December 30, 2024

**Chair Gregory Rondeau
Town of Franklin Planning Board
355 East Central Street
Franklin, Massachusetts 02038**

**RE: 55 Constitution Boulevard
Site Plan Review
Peer Review Response**

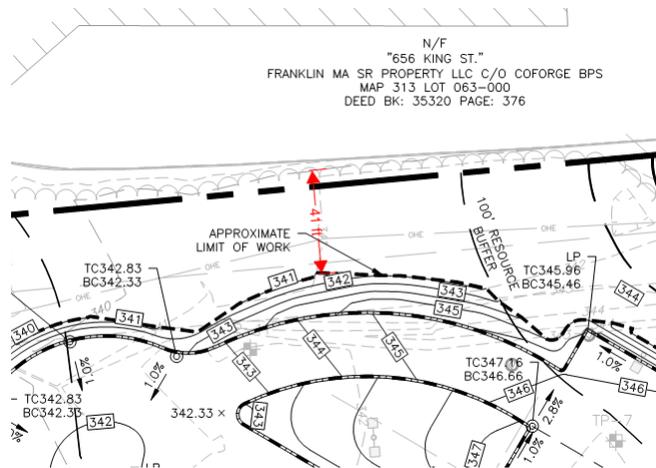
Provide required screening for the loading docks and parking areas associated with Building B. Based on BETA's site observations, the residential buildings at #648 and #656 King Street are readily visible from the existing Site, and proposed tree clearing will further reduce the vegetated area (§185-35.A)

BAI acknowledges Chapter 185 Section 35.A is applicable, however the following sections of the Bylaw reads as follows:

As noted in Section B, screening can be accomplished by any of the following: new plantings, a wall, an earthen berm 12" or more in height, or equivalent visual screening by

natural vegetation, or difference in elevation between potential viewers and the screened areas. Furthermore, as noted in Section C, for an industrial project such as this less than 500 feet from a residential use, a greenbelt not less than 15 feet wide containing a dense grouping of trees and shrubs providing a natural barrier between the lot and the premises must be provided.

As documented in the screenshot to the right, a natural greenbelt buffer approximately 41 feet wide at the narrowest has been provided between the access drive and the edge of the clearing on the adjacent property. As the greenbelt as is almost three times the required natural barrier in the bylaw, BAI believes adequate screening has been provided.

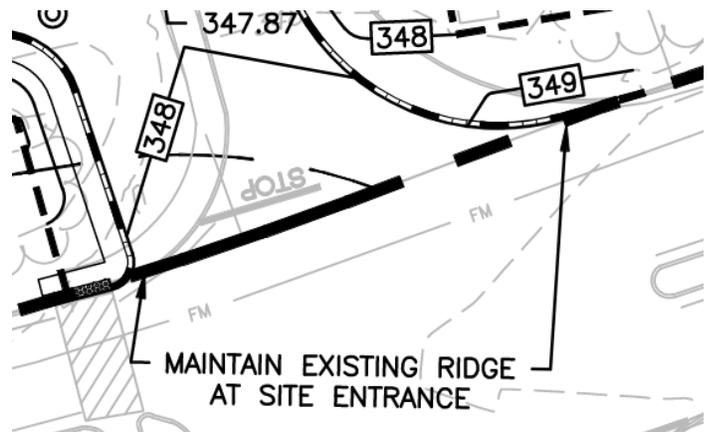
Provide contour labels for proposed grading between the eastern parking area and Constitution Boulevard to clarify design intent. Recommend extending limit of work to the existing 347' contour and providing spot grades to ensure that this area will properly drain to the parking area.

Additional contour labels have been added to the grading on the eastern side of the Building A parking adjacent to Constitution Boulevard. BAI does not agree that extending the limit of work to the 347 contour and clearing many of the trees and screening adjacent to Constitution Boulevard is appropriate nor necessary. The area is intended to remain as has been functioning for the past 23+ years.

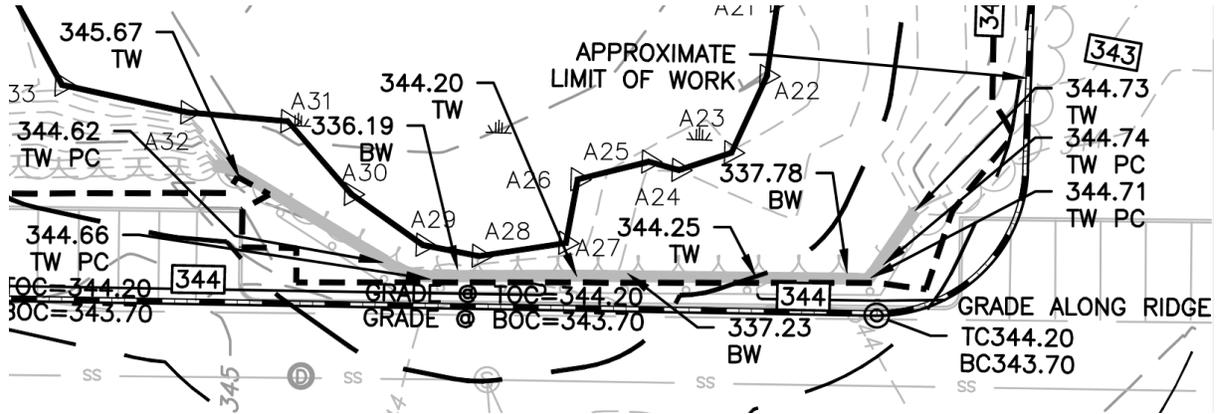
Provide spot grades along the top of the existing retaining wall to confirm that its height is suitable for the proposed grading.

Sheet C101, Supplemental Existing Conditions Plan as well as Sheet C130 Grading Plan, have been updated to include spot grades along the top of the existing retaining wall. BAI continues to believe the grading will function in harmony with the retaining wall.

Figure 1

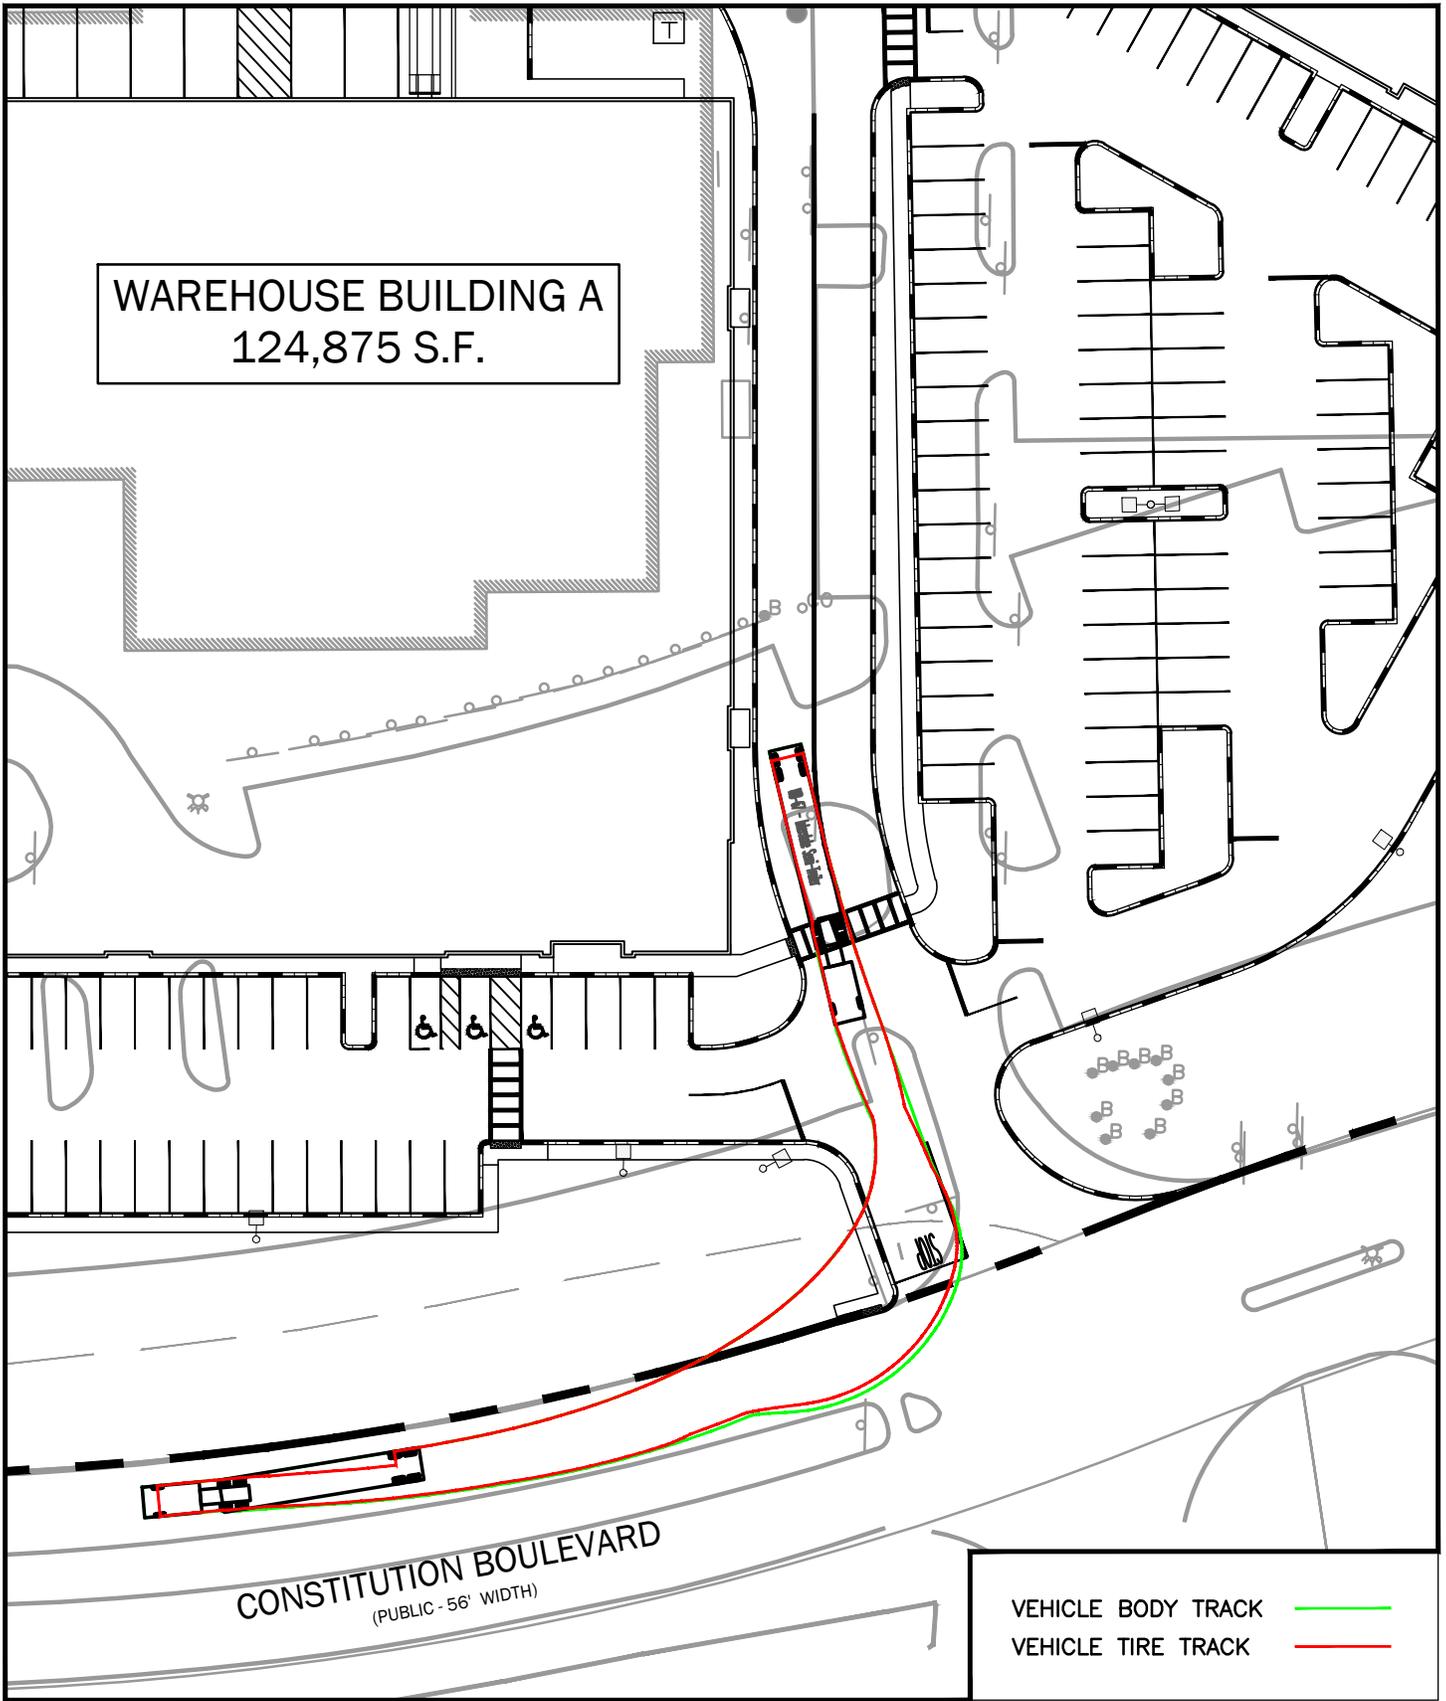
Include turning exhibit for WB-67 semi-trailer exiting the Site. A right-turn onto the southbound lane of Constitution Boulevard may not be possible due to the existing median.

A turning exhibit for a WB-67 semi-trailer was previously provided on Sheet C200, WB-67 Turning Analysis included within the planset. As demonstrated on the Plan, a WB-67 has sufficient space to exit the site northerly onto Constitution Boulevard. The site driveway was designed in a manner to prevent trucks from exiting the site in the southerly direction along Constitution Boulevard. A sketch demonstrating this has been attached with this letter under Attachment B.

Figure 2

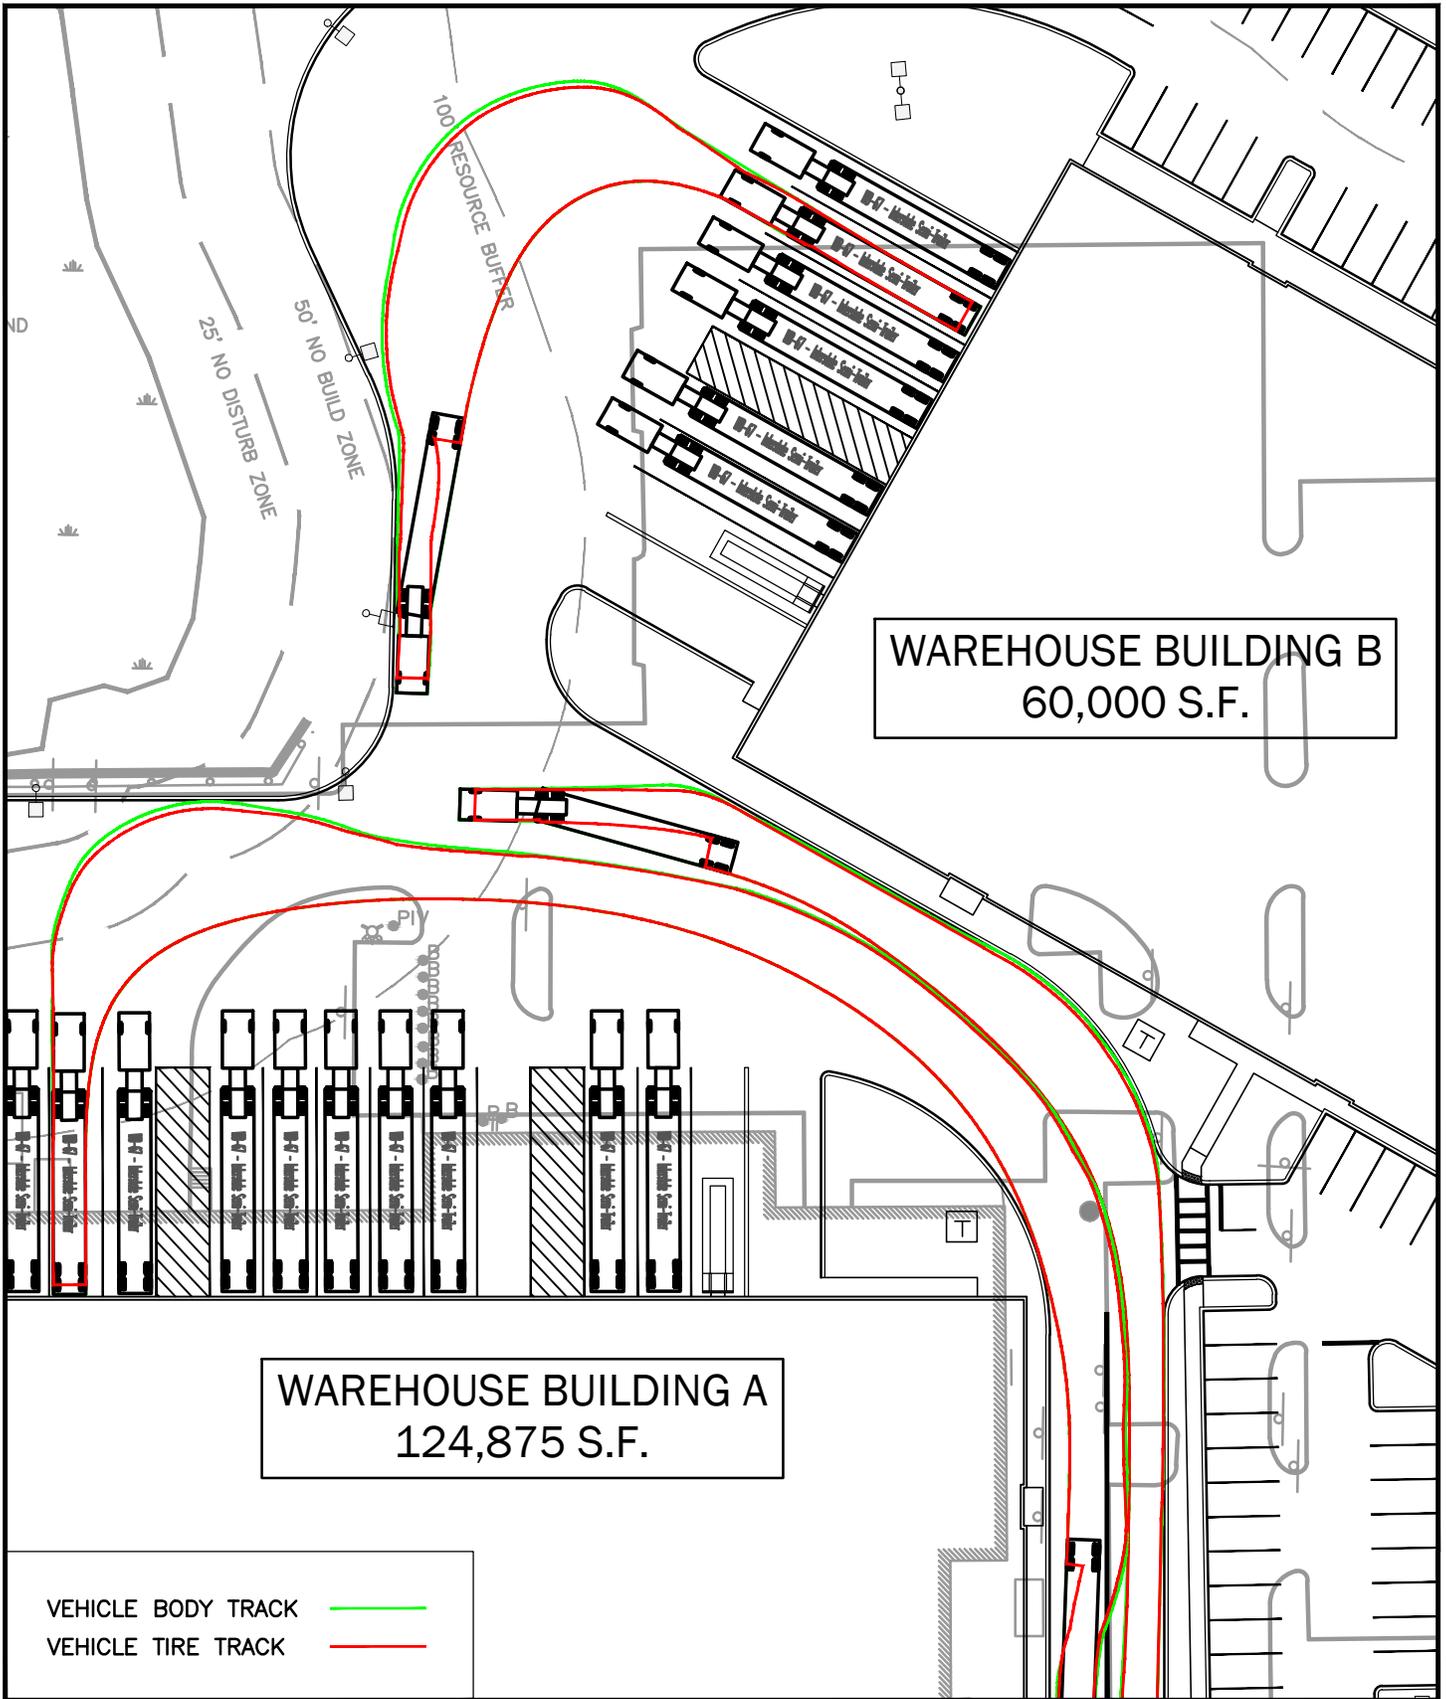
Include turning exhibits illustrating a WB-67 can back into the designate spaces, as well as their path when the exit the space.

The loading dock spaces for the proposed development have been designed to be 14 feet wide on center with a 130' apron as measured from the building face to the face of curb. This dimension is typical on industrial projects such as this and provide adequate turning for WB-67 trucks to navigate the docks. Sheet C200 in the planset has been revised demonstrating that there is sufficient space for WB-67 trucks to enter/exit the docks.

Sheet Number
C120

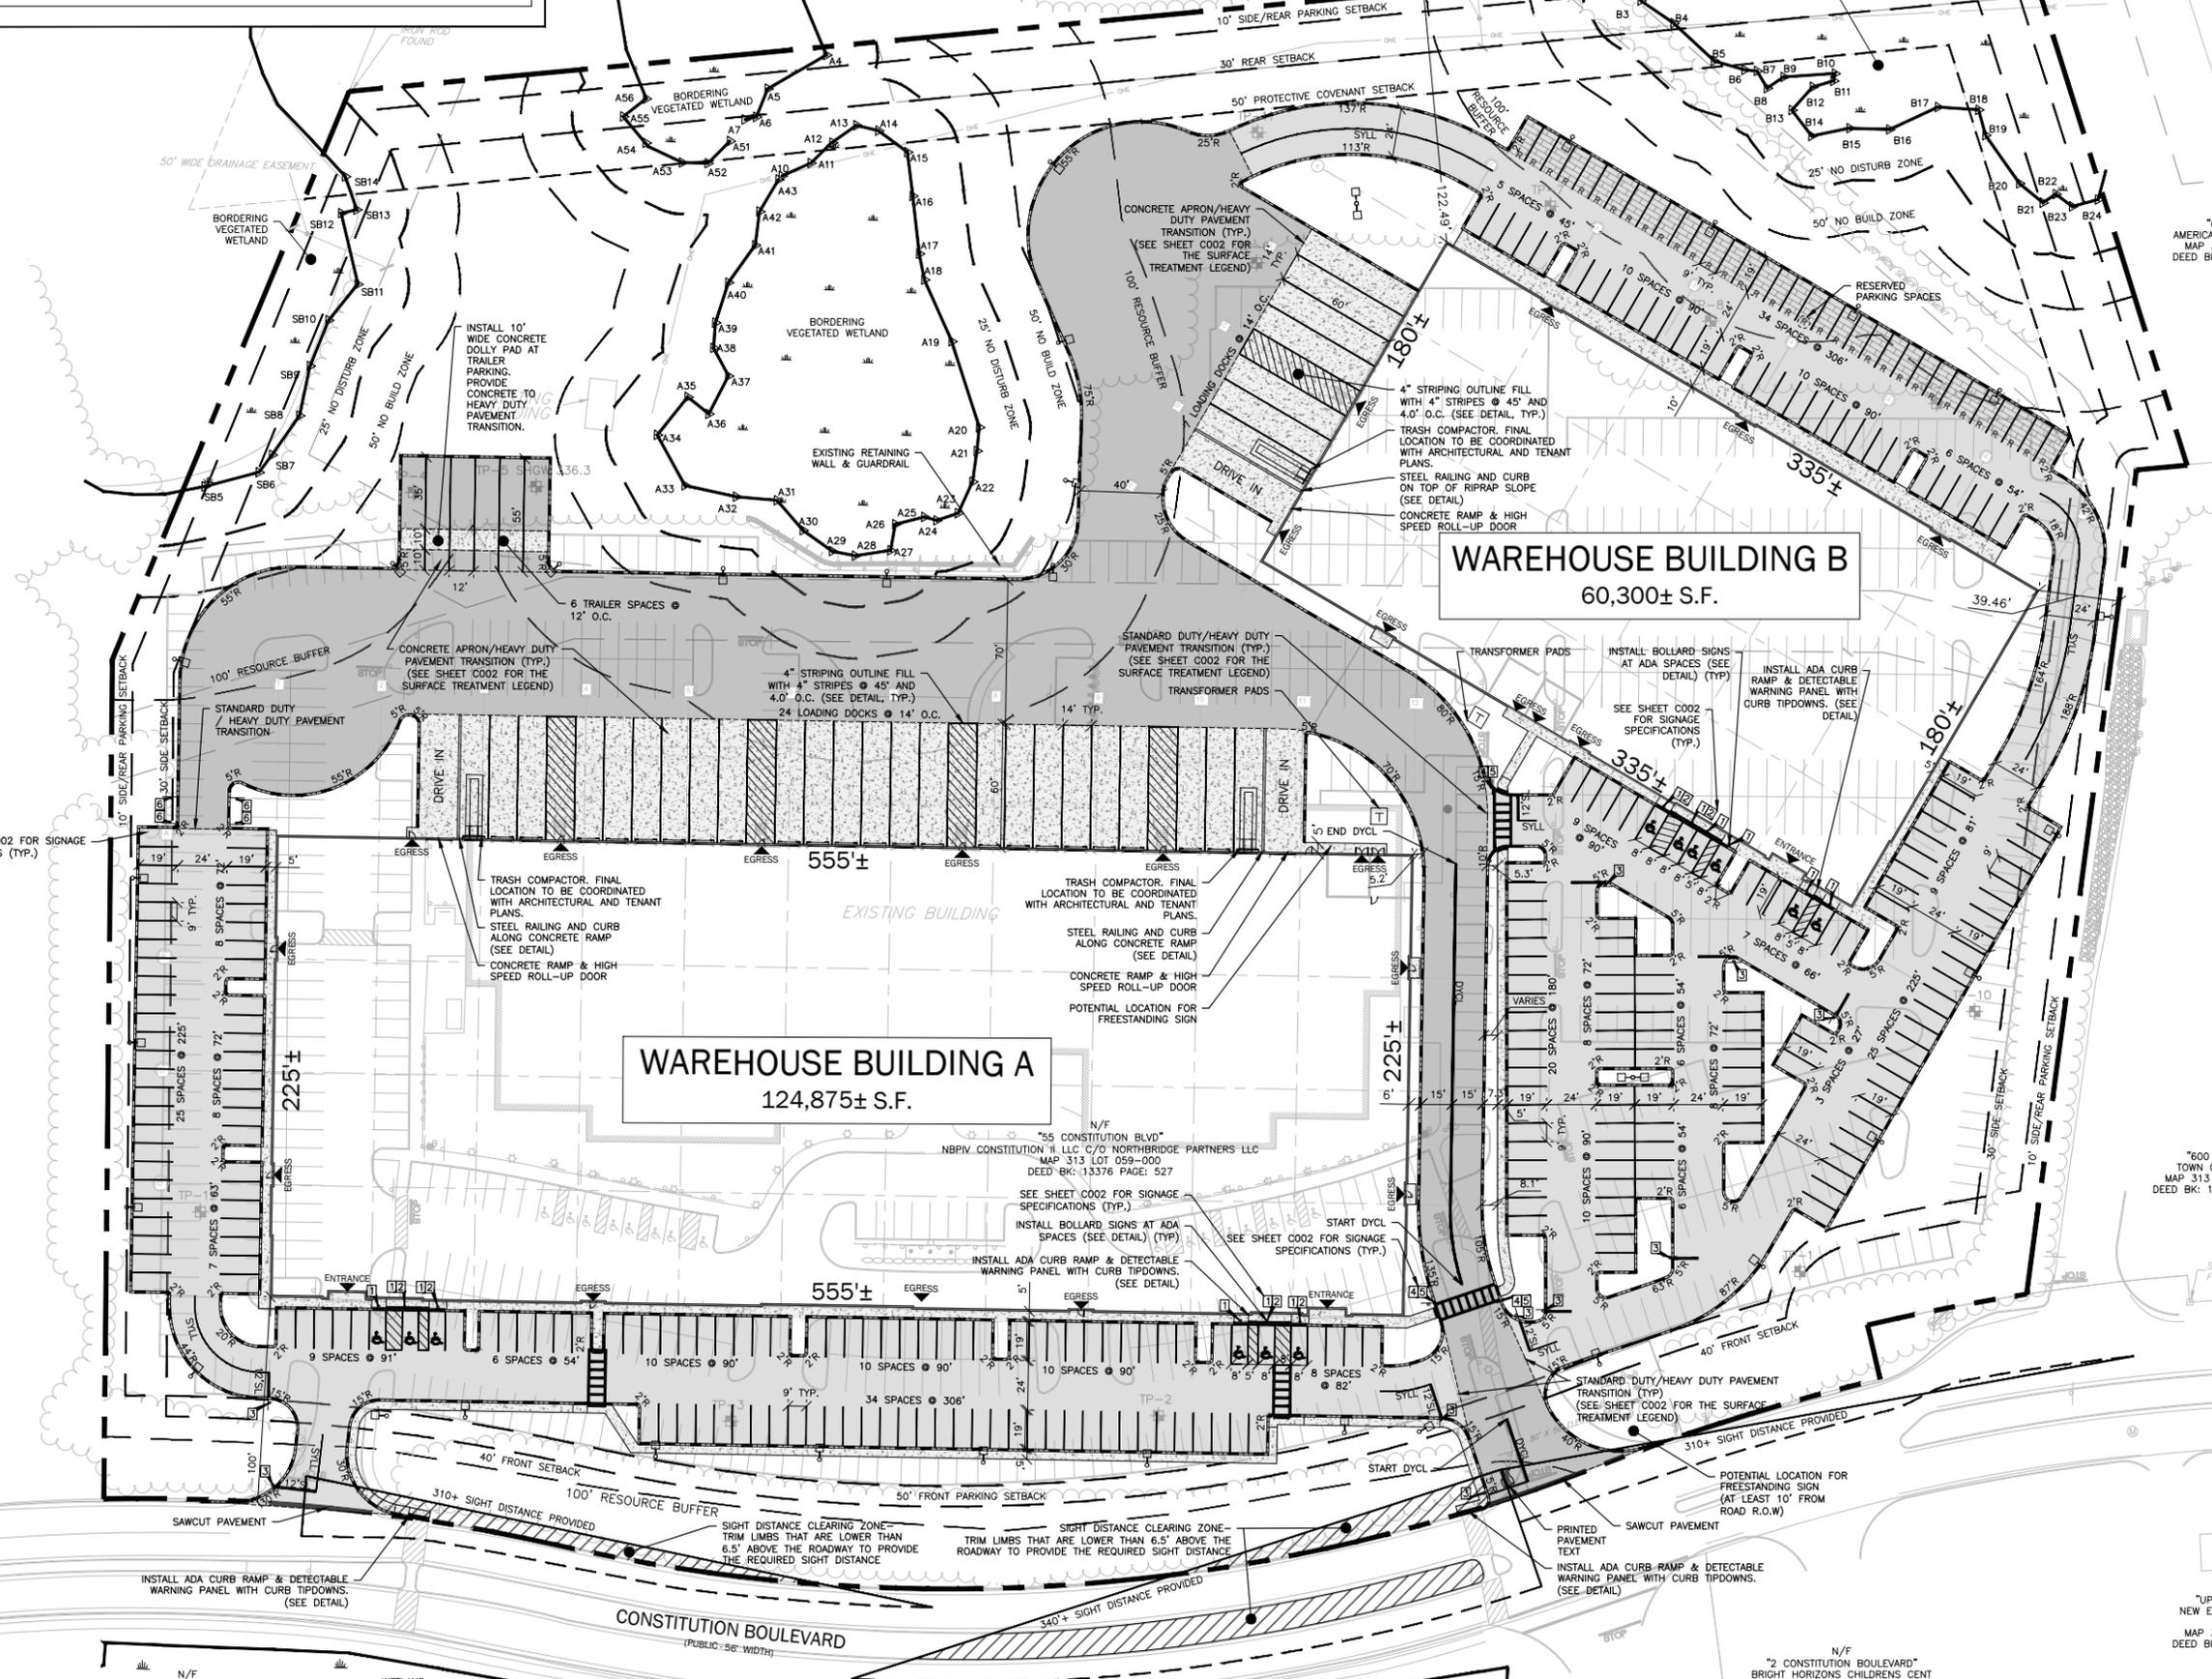
Evaluate if a building entrance could be provided in front of the accessible parking spaces for Building B. Per 521 CMR 23.3.1, accessible parking should be located on the shortest accessible route of travel to the building entrance. If an additional entrance not feasible, we recommended relocating the accessible spaces to be along either the east or west side of the building.

The accessible parking spaces have been relocated to provide the shortest accessible route of travel to the building entrances. See Sheet C120, Site Layout and Materials Plan.
